Memorandum from Department of Building Inspection, Portland, Maine

AP- 6.5 Congress Street

SUBJECT: Columbia Hotel, Inc., 645 Congress Street

Canopy on Front of Columbia Hotel - 645 Congress St

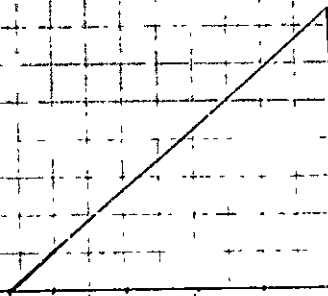
Permit amendment No. 3 covering construction of a canopy on front of building at above named location is issued herewith based on plans filed with application for amendment but subject to the following conditions:
